ARCHITECTURAL REVIEW COMMITTEE MEMORANDUM

SUBJECT: A REQUEST BY JERRY G. JOHNSON, ON BEHALF OF V.I.P. MOTOR CARS, LTD., FOR A MINOR ARCHITECTURAL (MAA) APPLICATION FOR PARTIAL DEMOLITION, A 1,973-SQUARE-FOOT ADDITION, AND EXTERIOR ALTERATIONS TO AN EXISTING AUTOMOTIVE DEALERSHIP BUILDING, GENESIS PALM SPRINGS, LOCATED AT 4057 EAST PALM CANYON DRIVE (APN: 681-070-034), ZONE C-2, SECTION 30 (CASE 3.1358 MAA). (NK)

PROJECT DESCRIPTION:

SHEET NAME
SITE PLAN

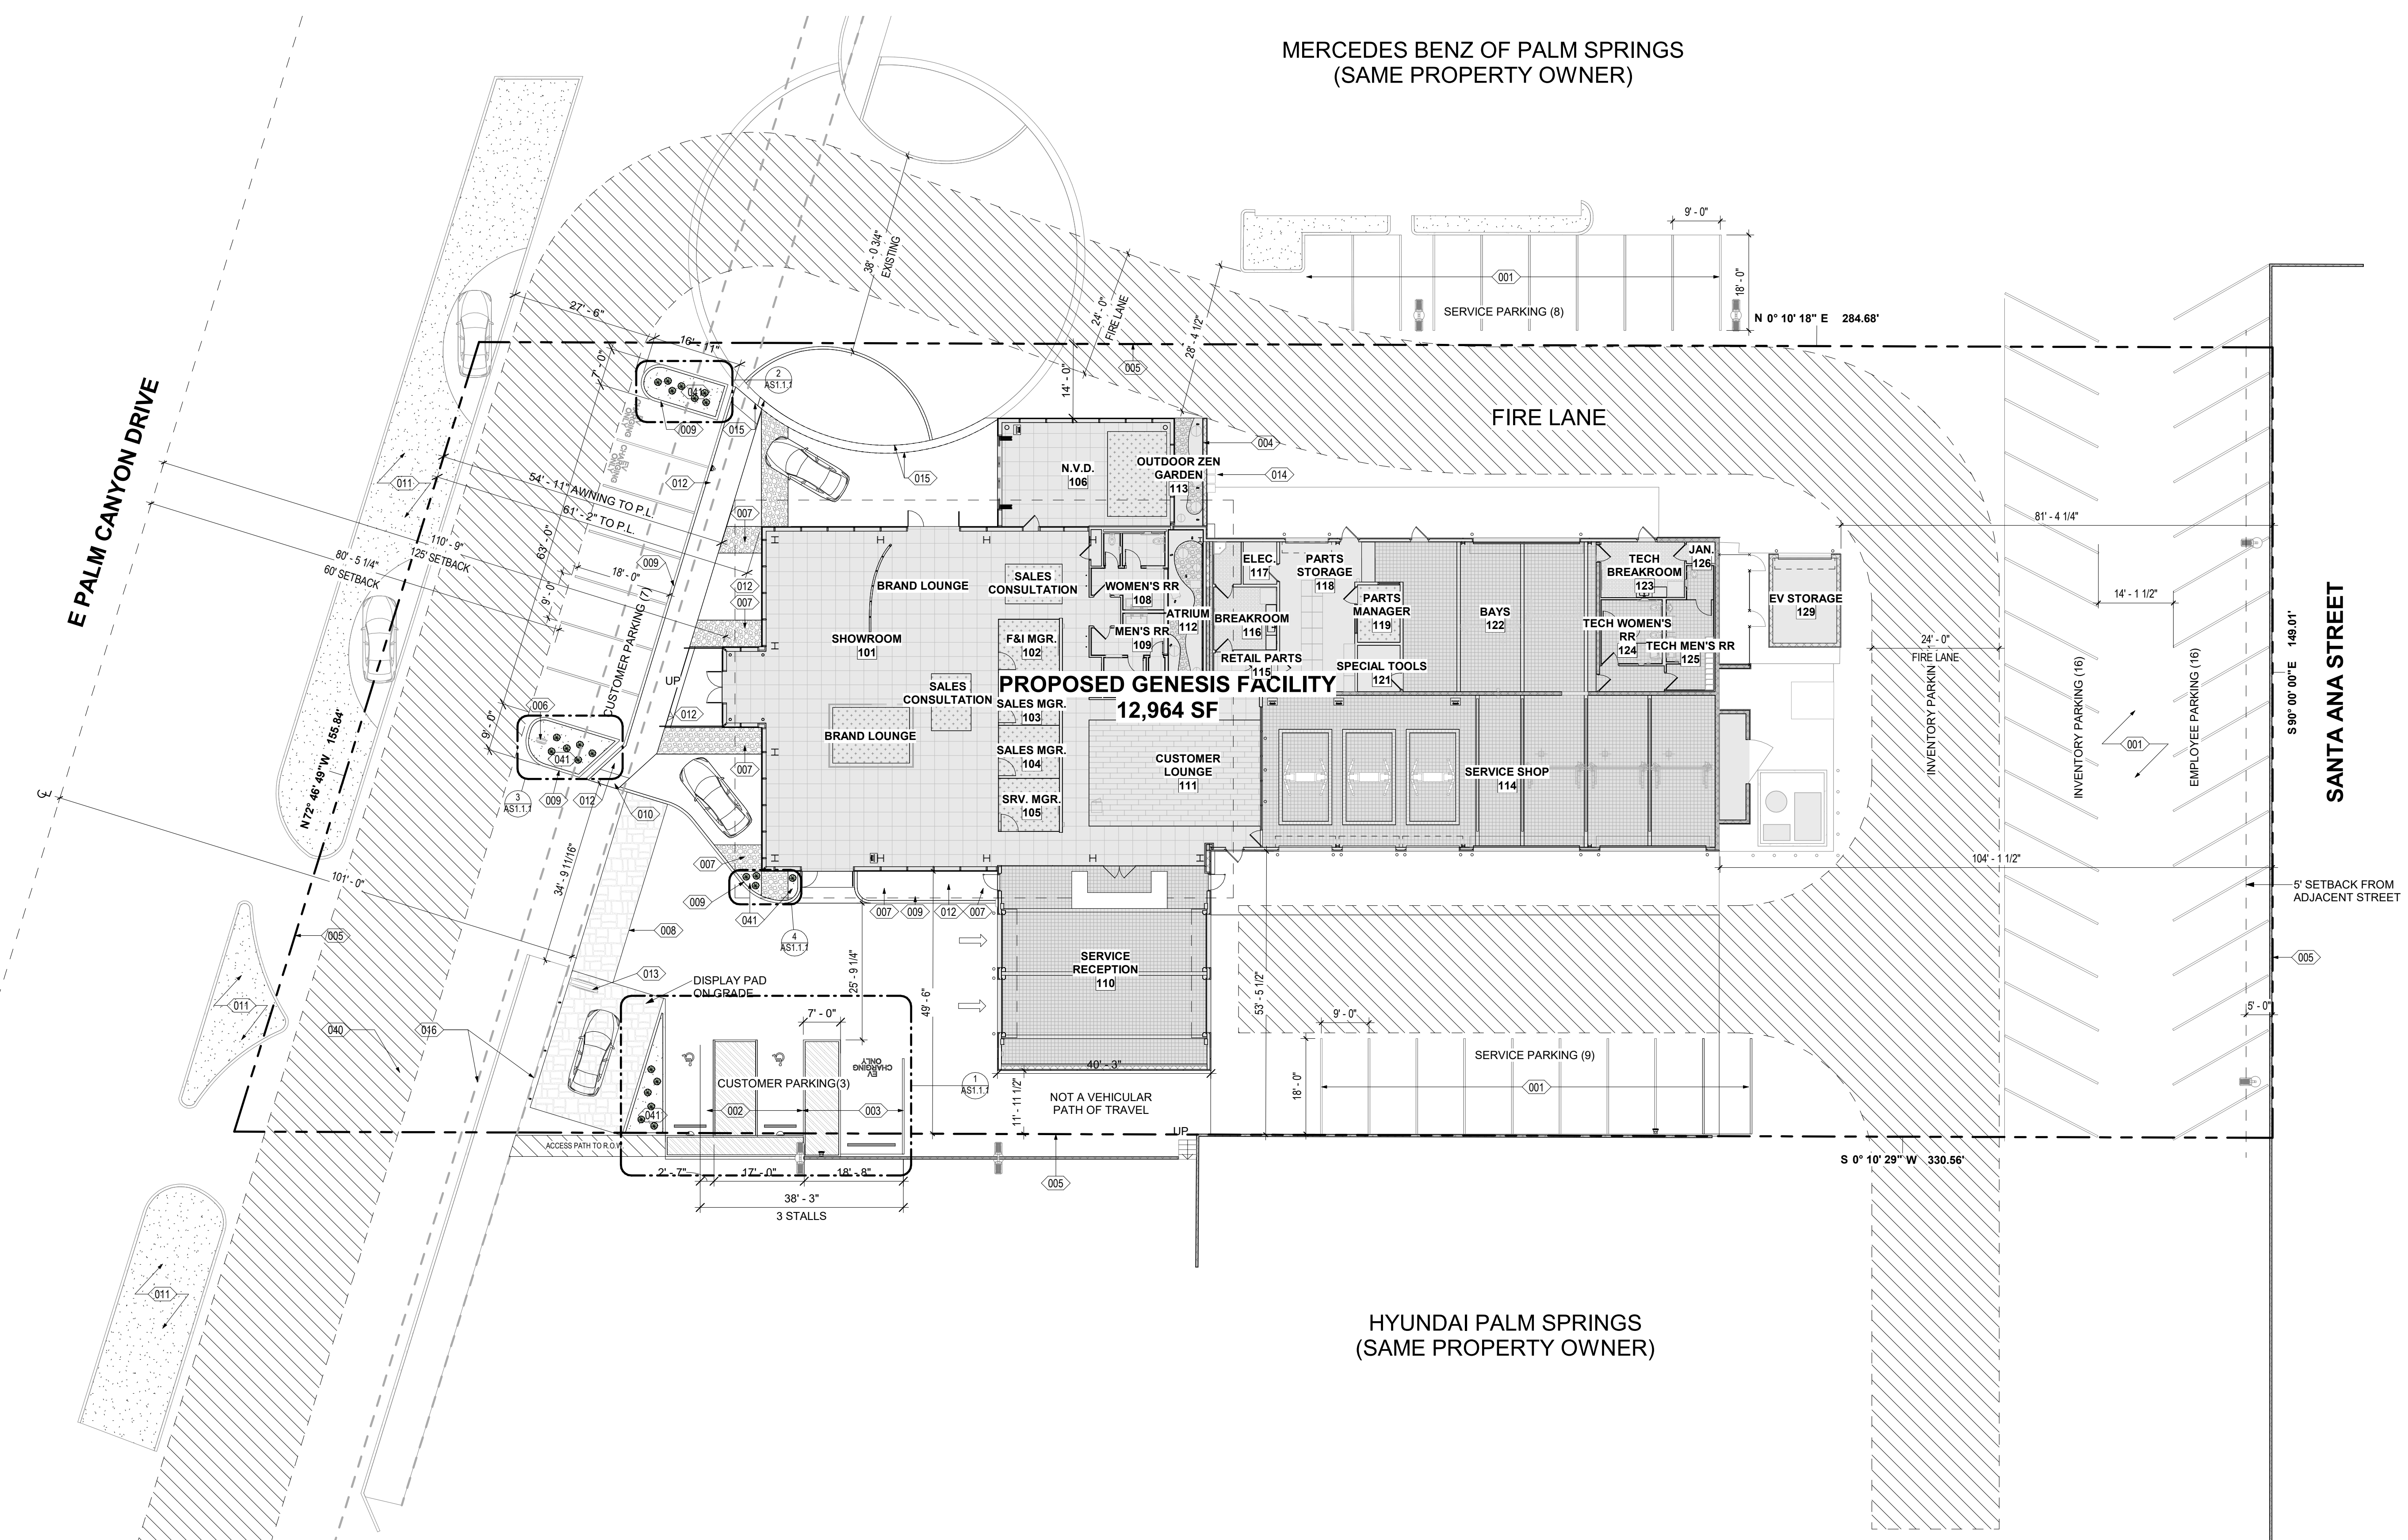
1. Except for one, the proposed parking area planting beds do not meet the minimum planting bed width of 9 feet required by the zoning code.
2. Only one plant material (Red Yucca) is proposed for the new parking area planting beds; there is no shade tree proposed for the new customer parking areas.

Standard	Required/ Allowed	Provided	Compliance
Max. Building Height	25 Feet	25 Feet*/Single-Story <i>*Excludes the rooftop mechanical equipment screen, which is allowed to exceed the building height limit per PSZC Section 93.03.00(A)(1).</i>	Y
Wall/Fence	6-foot-high wall along the south property line which abuts to the RMHP (Residential Mobilehome Park) Zone	Existing 6-foot-high wall along the south property line	Y
Parking	46 Spaces	46 Spaces* <i>*Although Sheet A notes 59, the site plan shows only 46 spaces on site</i>	Y

The primary customer parking area (north side) includes two planting beds, one of which is only 7 feet in width and substandard to the minimum planting bed width requirement of 9 feet. To address this issue, staff is recommending a condition of approval which requires the width of the 7-foot-wide planting bed to be increased to 9 feet. In addition to the primary parking area, the proposed secondary customer parking (west side) also includes a planting bed which is nonconforming to the minimum width requirement. Staff recommends a condition of approval which requires the conversion of the north-end handicapped space into a standard parking space and omission of the adjacent walkway to provide a 9-foot-wide planting bed and an 8-foot-wide access path for the handicapped/EV parking space as required by the zoning code. The conversion of one handicapped space into a standard parking space remains compliant as the zoning code requires two handicapped off-street parking spaces while the project currently proposes three.

Palm Spring Zoning Code Section 93.06.00(C)(3)(a) requires at least 30% of the parking area to be developed with shade trees. The proposed plant palette includes Red Yucca only, and there is no shade tree proposed. Staff is recommending a condition of approval which requires an increase in plant diversity and arrangement of the plants to achieve better composition, as well as the installation of shade trees in the new planting beds.

1. Convert the north-end handicapped space in the secondary customer parking area (west side) into a standard parking space and omit the adjacent walkway to provide a 9-foot-wide planting bed. Increase the shared pathway adjacent to the handicapped/EV charging space to 8 feet.
2. Increase the 7-foot-width of the planting bed in the primary customer parking (north side) to 9 feet to meet the code requirement.
3. Increase the plant diversity and arrange the plants to achieve better composition. Install shade trees in the new planting beds.

- PLN 3. Accessible Parking in Secondary Customer Parking (West Side). Convert the north-end handicapped space into a standard parking space and omit the adjacent walkway to provide a planting bed 9 feet in width. Increase the width of the access path on the right side of the van accessible handicapped/EV charging space to 8 feet.

- PLN 4. Primary Customer Parking (North Side). Increase the width of the 7-foot-wide planting bed to 9 feet.
- PLN 5. Sidewalk Easement. Locate the proposed primary customer parking (north side) out of the sidewalk easement or vacate a portion of the sidewalk easement and dedicate a portion of the project site to the City to address the encroachment issue.

- PLN 6. Plant Palette. Increase the plant diversity and arrange the plants to achieve sounding composition. Install shade trees in the new parking area planting beds.

1 ENLARGED ACCESSIBLE PARKING AREA
3/8" = 1'-0"

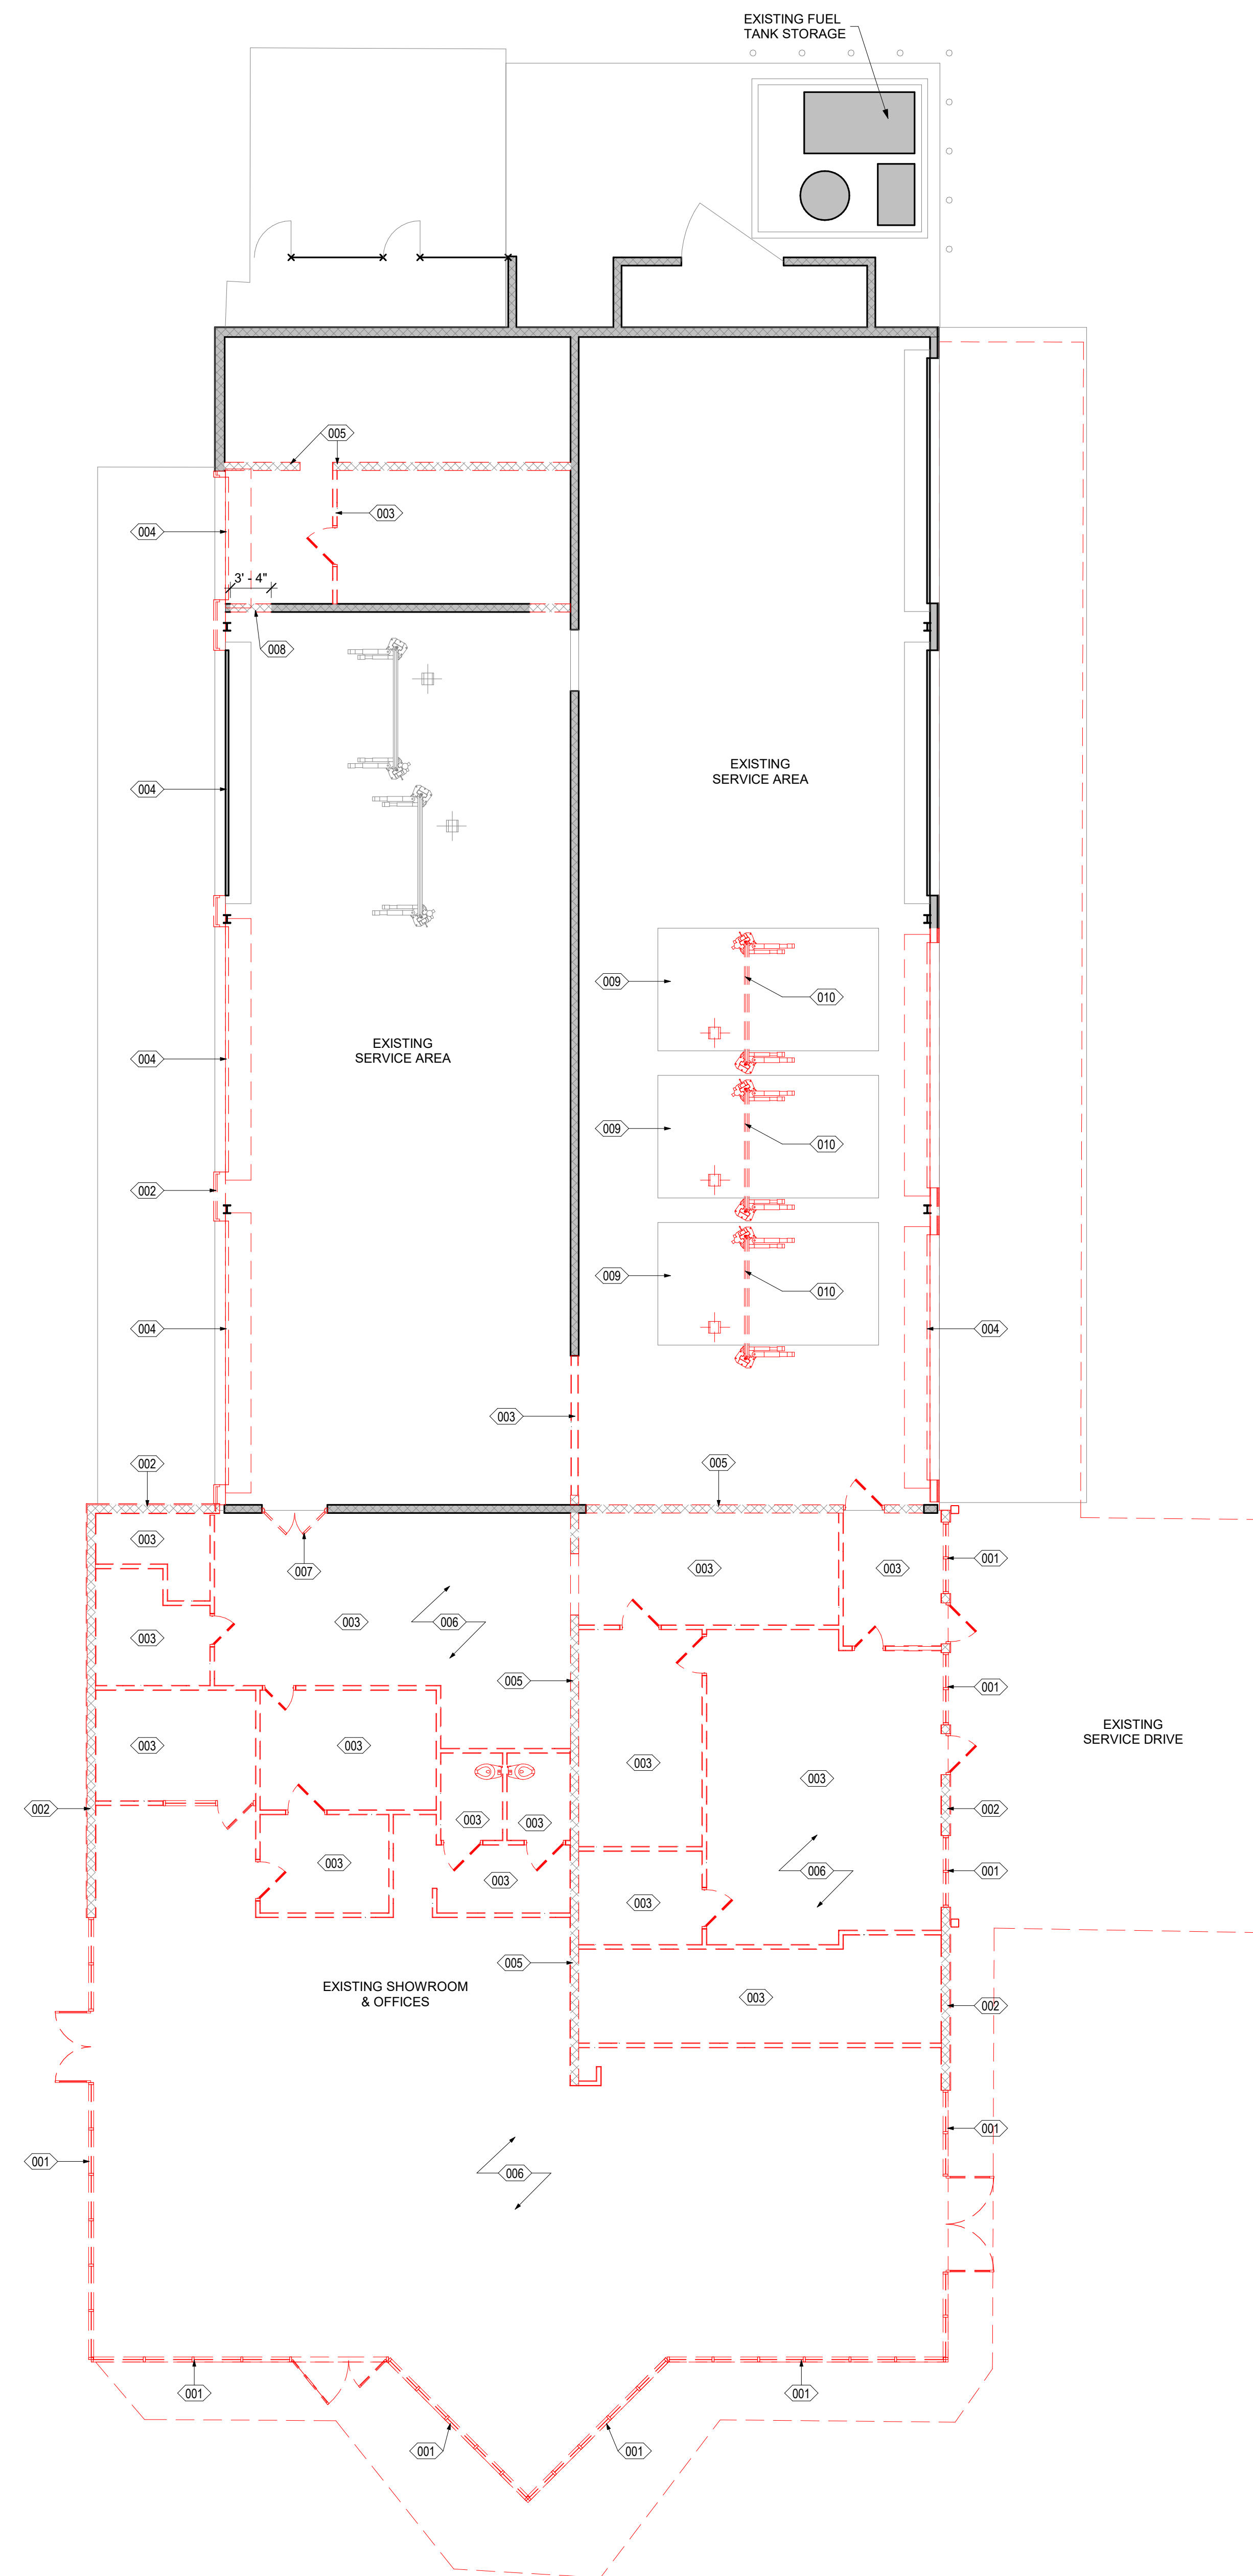
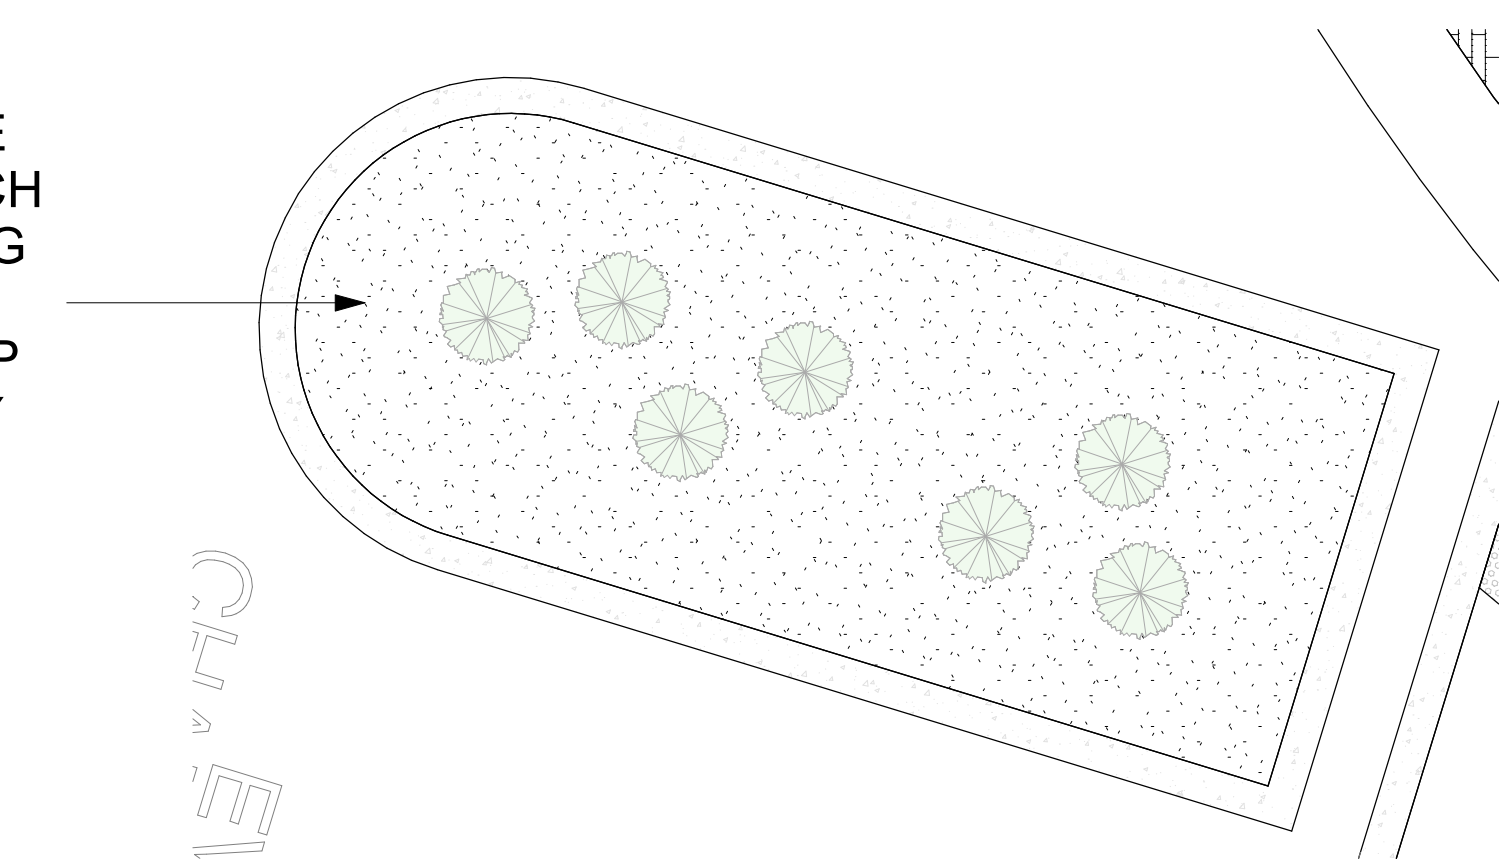
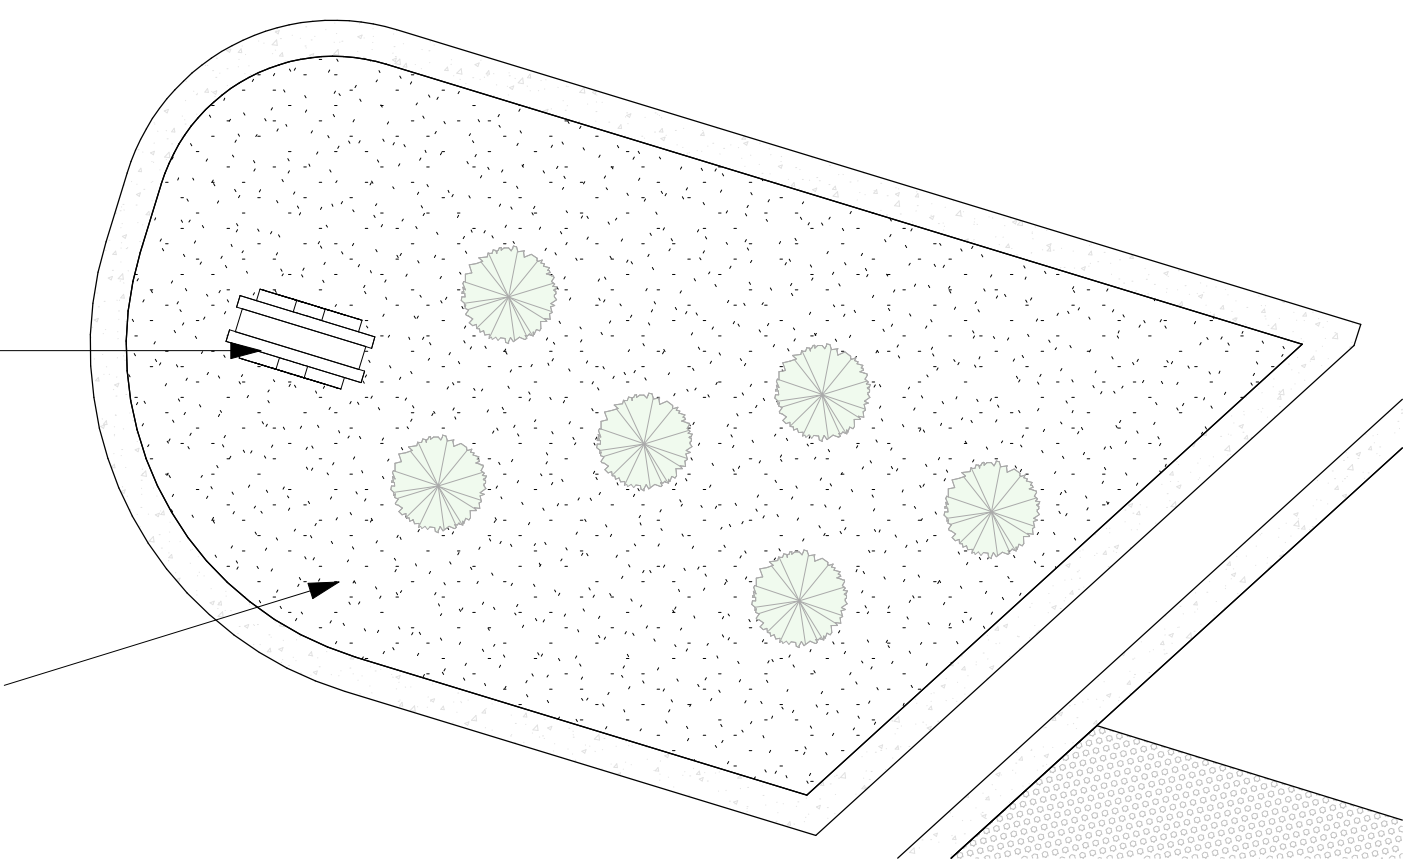
7.	<p><i>The proposed landscape plan is consistent with the requirements of PSMC Chapter 8.60;</i></p> <p>The project proposes the installation of Red Yucca (<i>Hesperaloe parviflora</i>) in the parking areas, which is on the plant list in the Lush and Efficient Landscape Guidelines. No turf is being proposed, and the proposed landscape will be irrigated via drip irrigation. Hence, the proposed landscape plan generally meets the requirements of PSMC Chapter 8.60.</p>	Y

8.	<p><i>The proposed landscape plan is consistent with all applicable zoning requirements, including any streetscape requirements, landscape buffer requirements, and screening requirements;</i></p> <p>Two of the four proposed planting beds are nonconforming to the minimum width requirement of 9 feet. Staff is recommending conditions of approval which require the width of the planting beds to be at least 9 feet for the substandard planting beds. The project proposes the installation of Red Yucca (<i>Hesperaloe parviflora</i>) only. While Red Yucca is on the plant list in the Lush and Efficient Landscape Guidelines, its sparse placement and single-plant landscape plan appear too monotonous and incomplete. In addition to the conditions mentioned earlier, staff is recommending a condition of approval which requires an increase in plant diversity and improved composition in each planting area to better complement the building, as well as the installation of shade trees. As conditioned, the proposed project meets this requirement.</p>	Yes, as conditioned
